**LOS ANGELES REGION  
UNIFORM CODE PROGRAM**

**RECOMMENDED TECHNICAL  
AMENDMENTS TO THE  
2010 CALIFORNIA BUILDING CODE,  
2010 CALIFORNIA RESIDENTIAL CODE,  
AND  
2010 CALIFORNIA GREEN BUILDING  
STANDARDS CODE**

**Final Draft: August 26, 2010**

**ICC LOS ANGELES BASIN CHAPTER'S  
STRUCTURAL CODE COMMITTEE,  
CRC CODE COMMITTEE, AND  
GREEN BUILDING STANDARDS CODE COMMITTEE.**

**TABLE 2306.2.1(3)–continued**  
**ALLOWABLE SHEAR (POUNDS PER FOOT) FOR WOOD STRUCTURAL**  
**PANEL DIAPHRAGMS WITH FRAMING OF DOUGLAS FIR-LARCH,**  
**OR SOUTHERN PINE<sup>a</sup> FOR SEISMIC LOADING<sup>f</sup>**  
**FOR STRUCTURES ASSIGNED TO SEISMIC DESIGN CATEGORY D, E OR F**

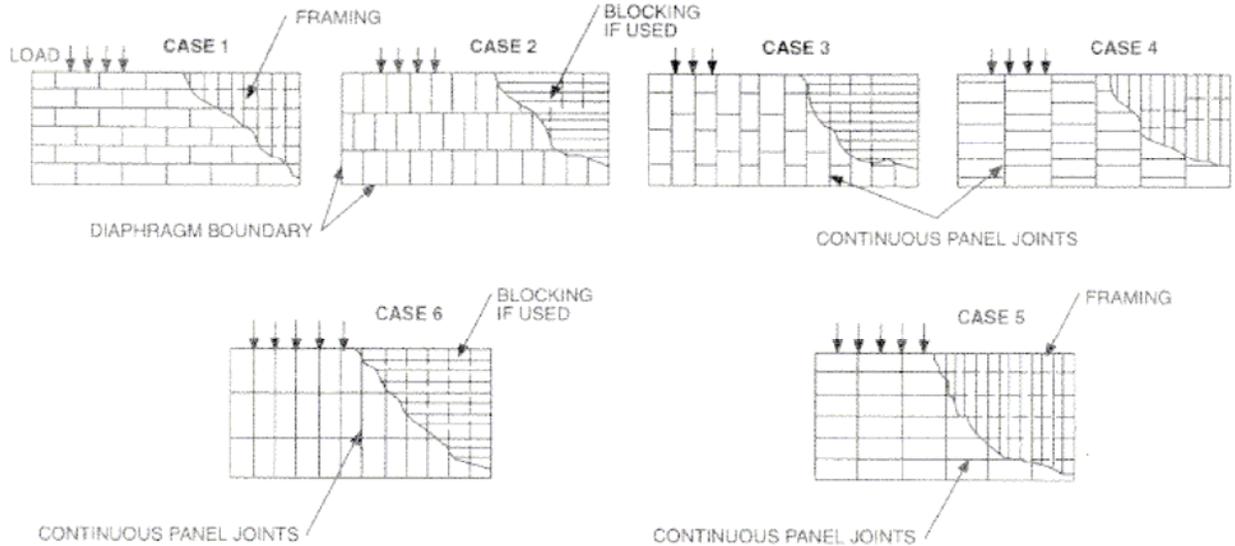
**2010 LARUCP 23-04.** Tables 2306.2.1(3) and 2306.2.1(4) are added to Chapter 23 of the 2010 Edition of the California Building Code and Section 2306.2.1 of the 2010 Edition of the California Building Code is amended to read as follows:

**FIGURE R403.1.5**  
**STEPPED FOOTING**

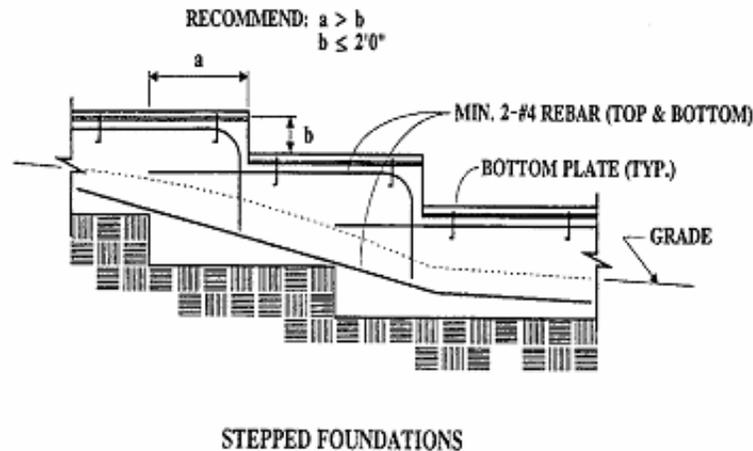
For structures located in Seismic Design Categories D<sub>0</sub>, D<sub>1</sub> or D<sub>2</sub>, stepped footings shall be reinforced with four 1/2-inch diameter (12.7 mm) deformed reinforcing bars. Two bars shall be place at the top and bottom of the footings as shown in Figure R403.1.5.

**FIGURE R602.10.3.2  
ALTERNATE BRACED WALL PANEL**

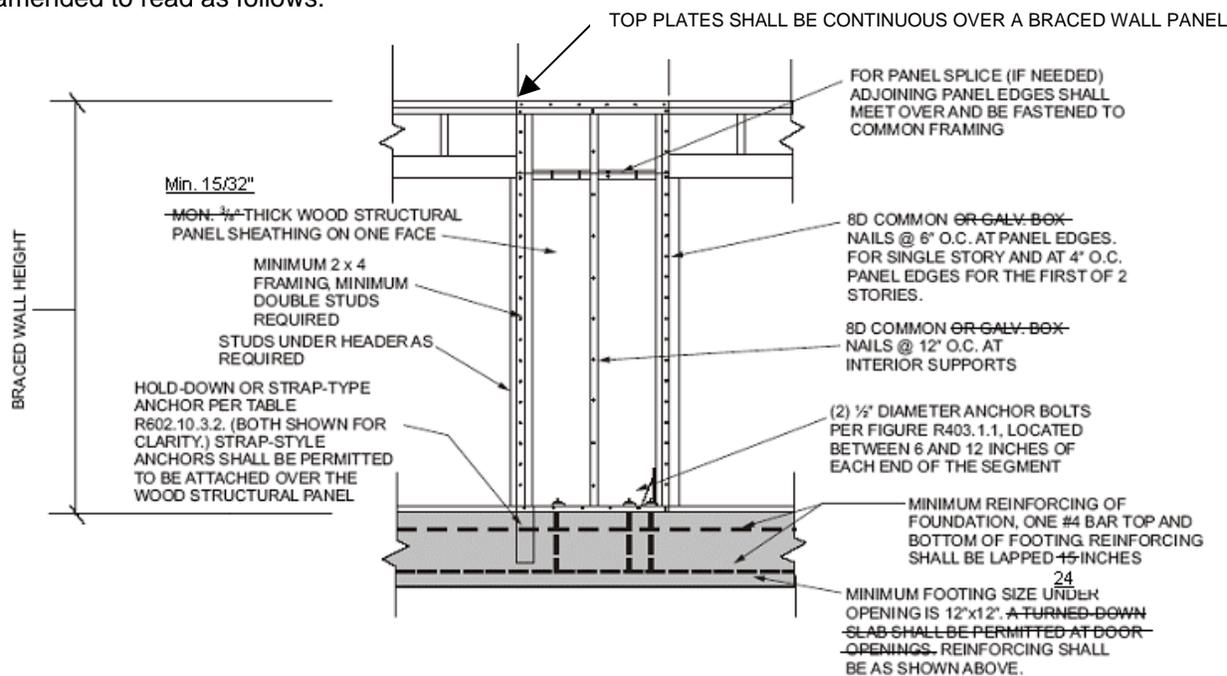
**2010 LARUCP R6-05.** Figure R602.10.3.2 of the 2010 Edition of the California Residential Code is amended to read as follows:

FIGURE R602.10.3.3

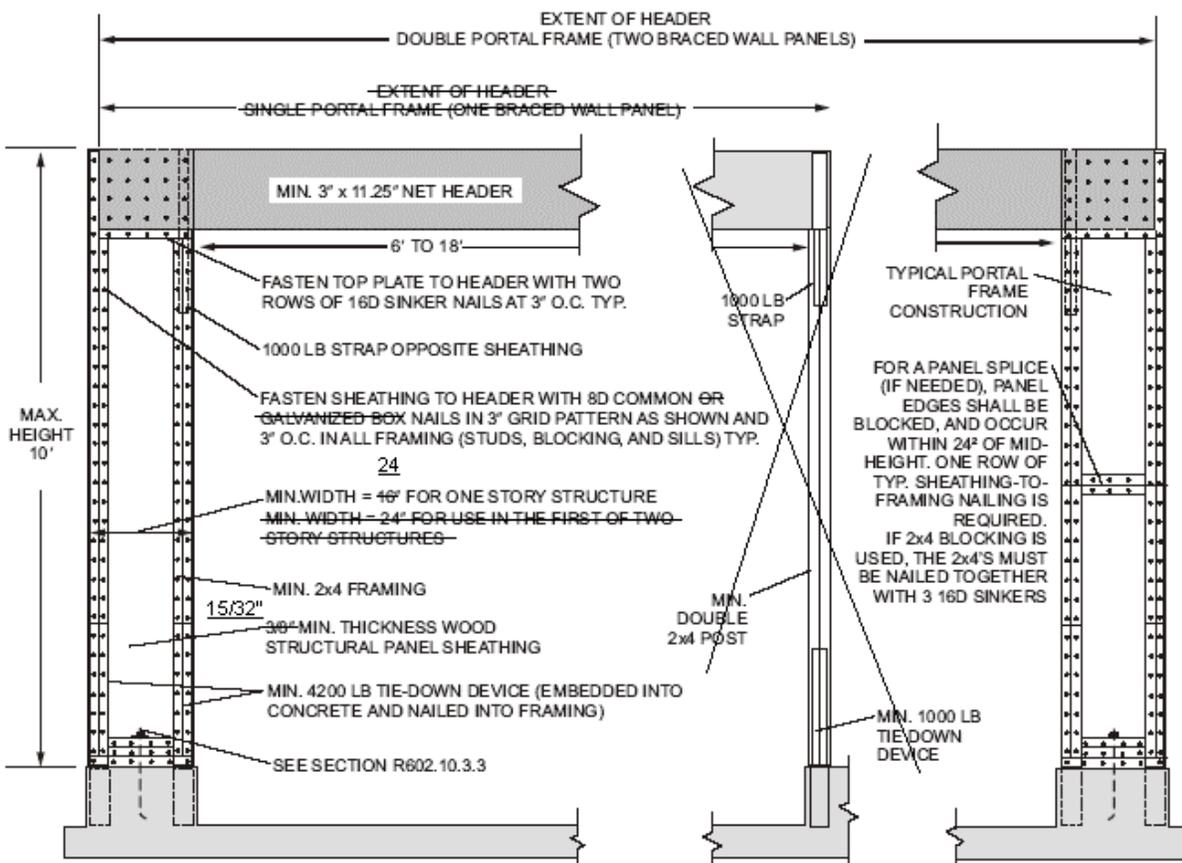
**2010 LARUCP R6-06.** Figure R602.10.3.3 of the 2010 Edition of the California Residential Code is amended to read as follows:
